**UTS Central Project**  
Section 4.55 (1A)  
Design Statement

Project Name	UTS Central Project		
Project Code	UTSC		
Document Name	Section 4.55 (1A) Design Statement		
Document ID	UTSC Section 4.55		
Revision	Date	Comment	Approved
1	18.05.2018	DA Section 96 Issue -Draft Issue	JP
2	30.05.2018	DA Section 96 Issue -Draft Issue	JP
3	08.08.2018	Section 4.55 (1A) Application	JP

UTS are now seeking to submit a Section 4.55(1A) application to modify the above consent (SSD\_7382). The application seeks approval for the following:

Proposed Level 4 indicating location of Substation Ventilation in Phase 1

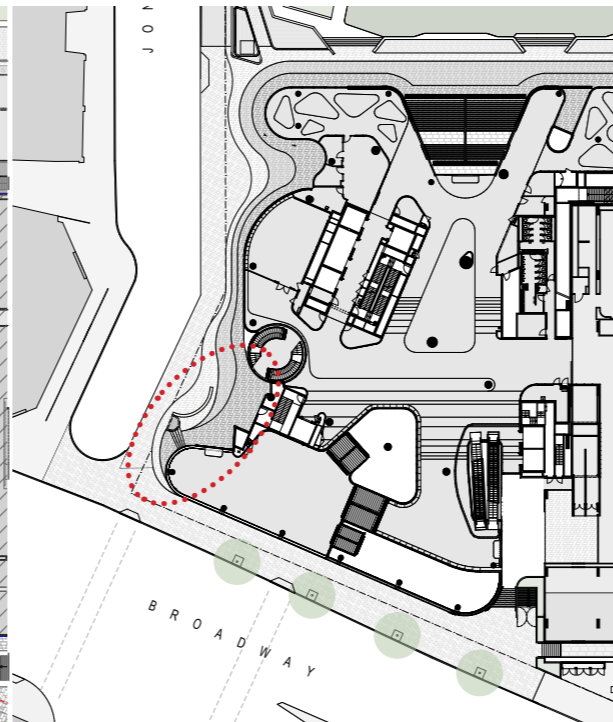
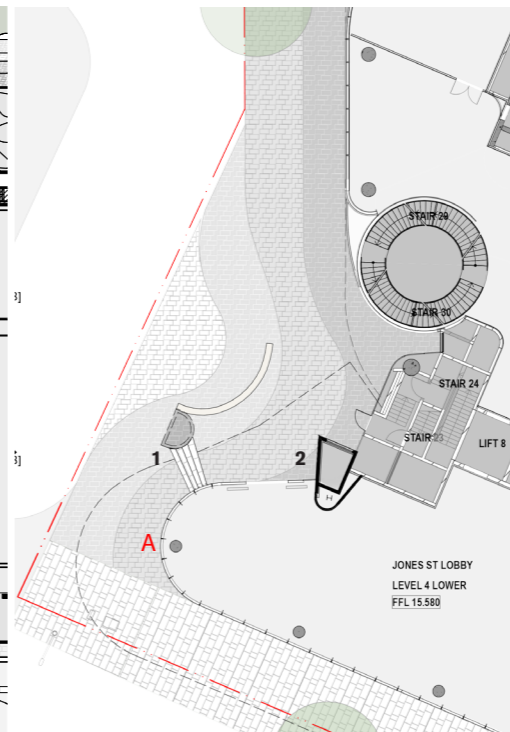
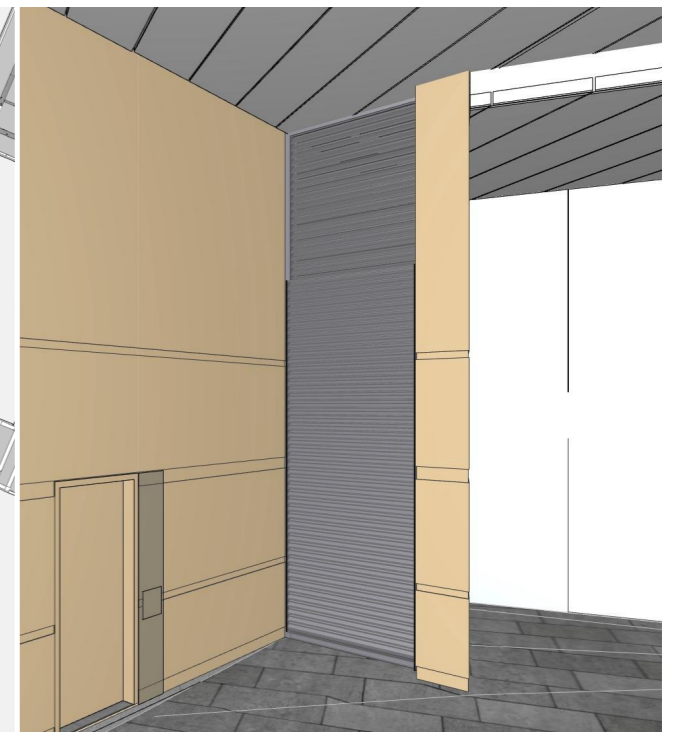
The proposed substation ventilation has been represented in this submission as required by Ausgrid for the substation located on level 2 under the footpath and as part of the development for CB02.

It has been located in this position in response to the requirements and clearances as defined by Ausgrid and with consideration of the significant existing services and infrastructure located in this area. The stairs located between the building facade and the ventilation stack provide direct access to the Jones Street entry.

The intake for the substation is the stand-alone ventilation stack along Jones Street while the exhaust ventilation stack for the substation is adjacent to the facade on Jones Street.

The proposed finish of the substation ventilation stack is rendered and painted to match the same on the Alumni Green facade.

Level 4 modified - facade line showing area of change

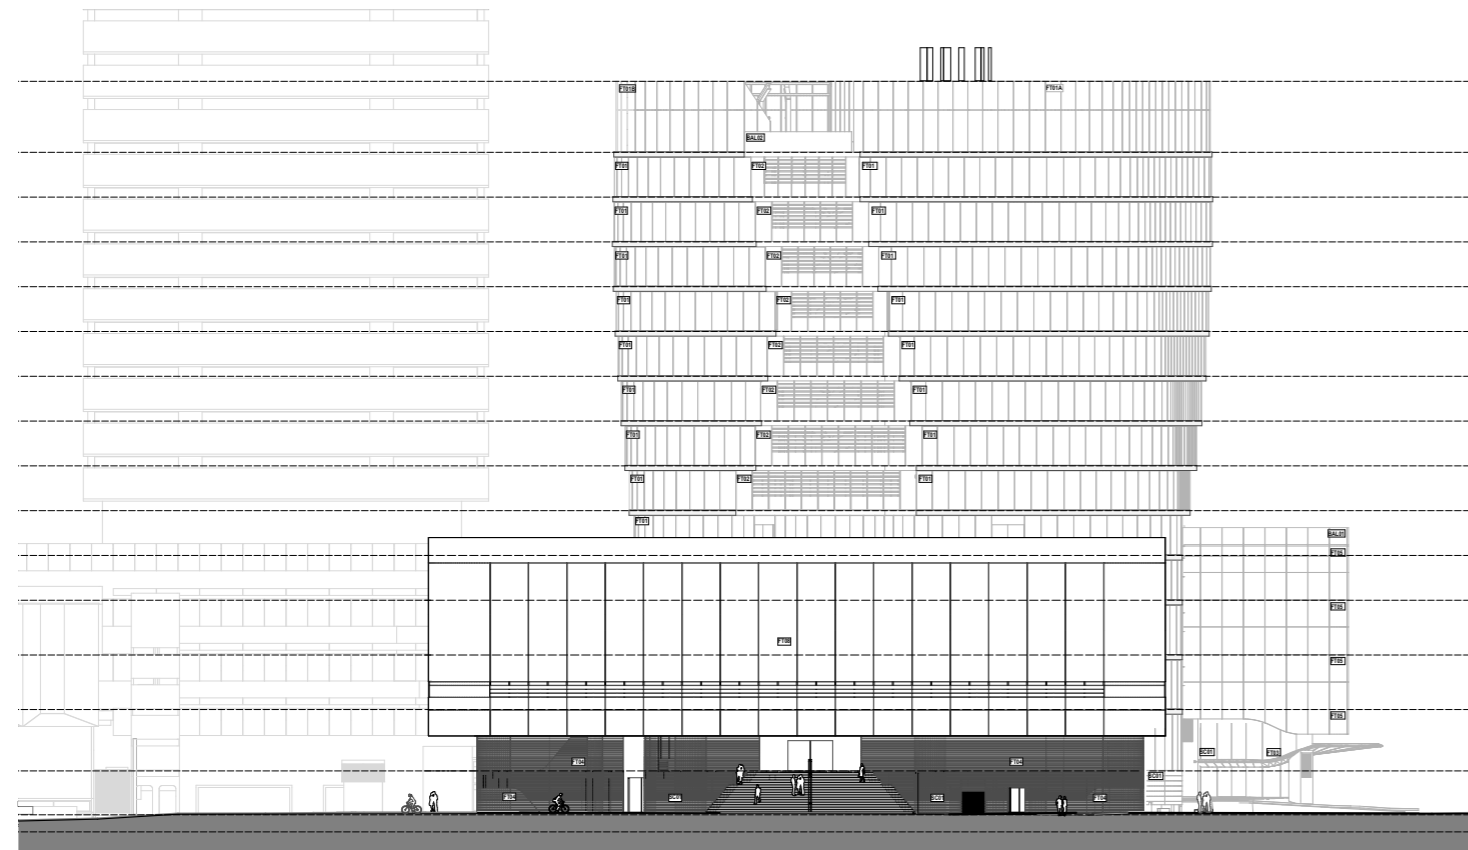
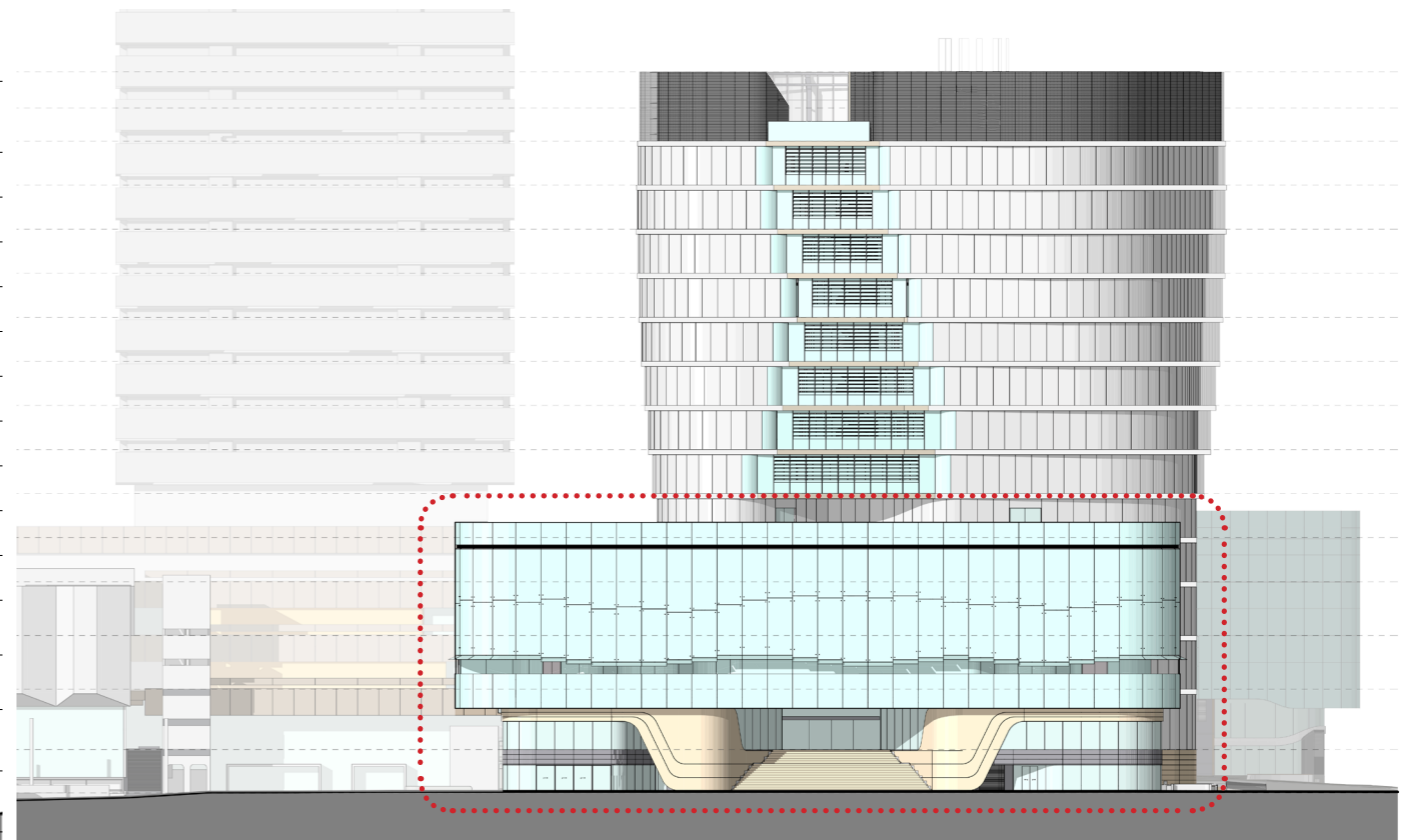
The proposed adjustment to the Alumni Green facade is a response to the significance, scale and interface of this facade to Alumni Green. The articulation of solid and transparent of the Alumni Green facade places emphasis on the primary entry and staircase to CB02 which is located in the centre of the elevation to Alumni Green. The facade is solid as it turns into the stair on either side, framing the stairs and entry and extends from level 3 to the underside of level 5. This articulation shifts on either side of the stair to provide a greater transparency and "lightness" to the east and west ends of both level 3 and level 4.

The overall facade of solid to transparent on levels 3 and 4 reinforce the composition of the overall facade and emphasises the relationship and significance of the clear facade and form of the Reading Room and the articulation and mass of level 3 and 4.

The Reading Room facade has been further developed to show glass joints that are not in continuous alignment across the facade but rather adjust up and down across the facade. This helps to generate a playful pattern across the long facade facing onto Alumni Green. The openings along this facade at level 5 have also been adjusted to provide a larger continuous opening located above the balustrade on the level 5 Reading Room verandah.

The solid component of the Alumni Green facade on levels 3 and 4 is rendered and painted.
